Agenda Item:	SU.16.3961 Car Wash	**Agenda Date:**	Dec 14, 2016
Originated by:	Christopher M. Gratz, AICP	**Agenda Placement:**	Public Hearing
Authorized by:	Catherine Hartley, AICP, CNU-a

PROJECT #: SU.16.3961 Car Wash
TO: Mayor & City Council
FROM: Christopher M. Gratz, AICP, Development Services & Zoning Manager
DATE: 11/9/2016, revised for 12/14/2016
APPLICANT: Christopher McGill, agent for 2710 East Manatee Avenue, LLC, owner
WARD: 5, Harold Byrd, Jr.

Project Name: MB.16.3356 Car Wash
Review Date: September 14, 2016
Site Address: 2710 Manatee Avenue East

SHEET C1.02

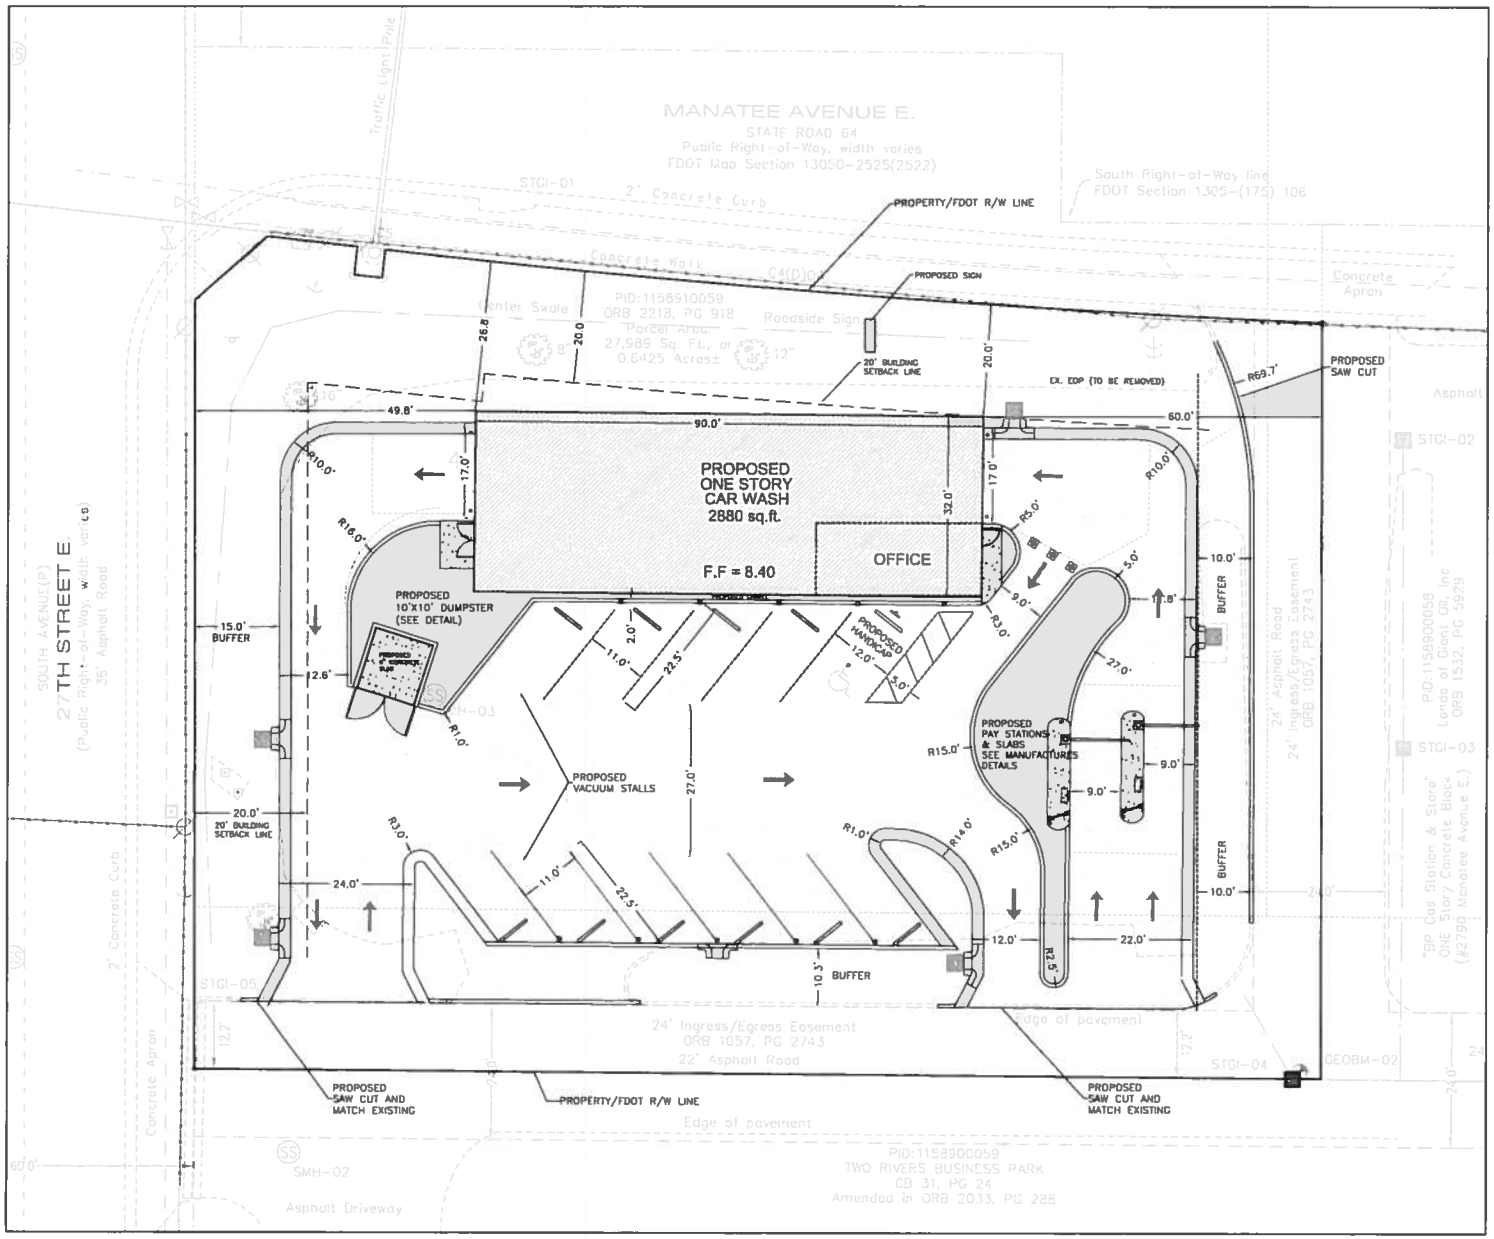
2. The revised landscape strip on the eastern boundary does not comply, this needs to start at the property line/access easement. A landscaped separation strip of at least ten feet in width shall be provided along all property lines and along all streets serving the premises, except at approved access points. §3.3.1.2

3. Show that adequate vehicle stacking is being provided. Stacking lanes for all drive-through operations shall have a minimum width of nine feet per lane and shall be of sufficient length to accommodate five (5) vehicles, including the vehicle at the pickup window. The PCD director may, under certain circumstances, allow relief from this standard. Site specific design and location shall be determined by the PCD director and fire marshal. §4.1.4.3

SHEET
LA-1

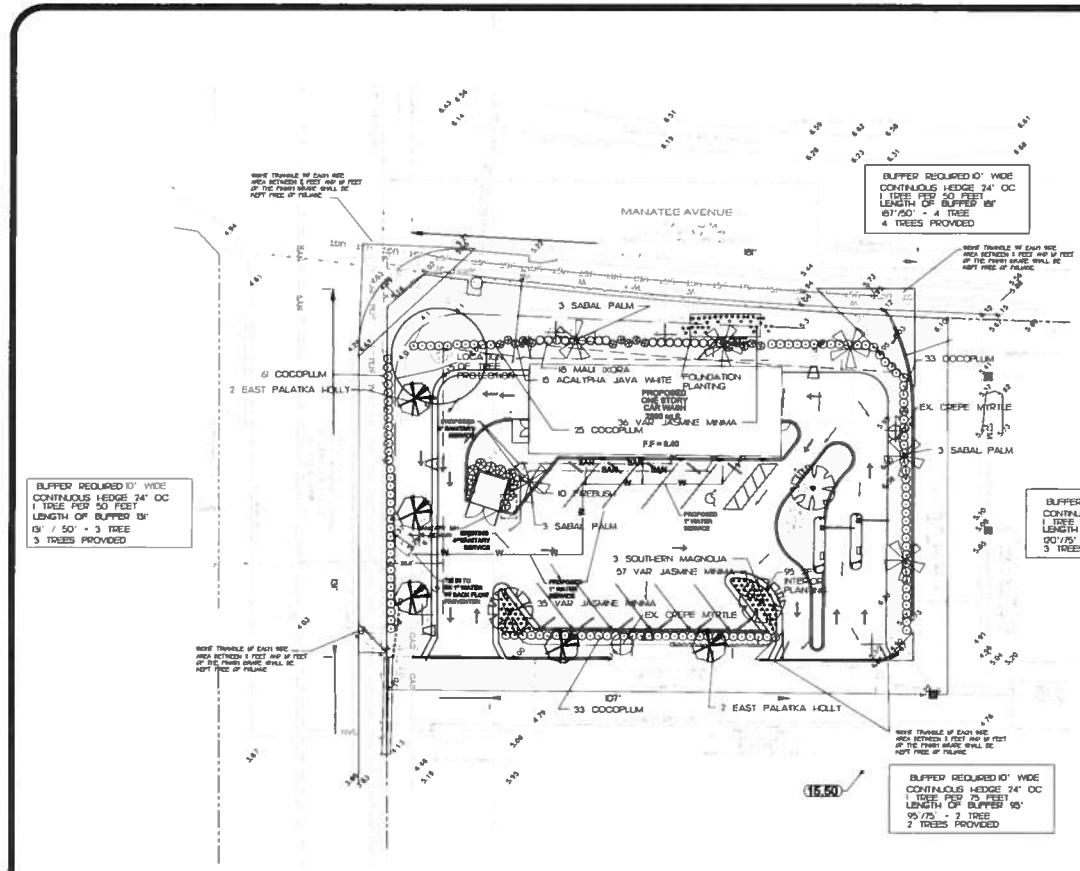
5. Submit a plan clearly showing all existing trees to be removed. There are two (2) crepe myrtles missing from the plans; there is one (1) on eastern boundary near the existing entrance, and there is another one on the southern boundary west of the vacuum station.
   5.1. There are 12 Sabal Palms which are considered non-significant trees requiring 1:1 replacement ratio with a minimum diameter 2 inch caliper, 6 foot tall, Florida #1 grade tree. §2.2.3.1.

6. Royal Palm trees cannot be used to mitigate the removal of Live Oak trees. Only Live Oak trees may be used and there must a valid reason to remove them. §2.2.3.1.e. and §2.2.3.2.

7. All of the buffer, foundation planting, and interior planting requirements quoted on the plans are incorrect. Schedule 4.1.4.4.
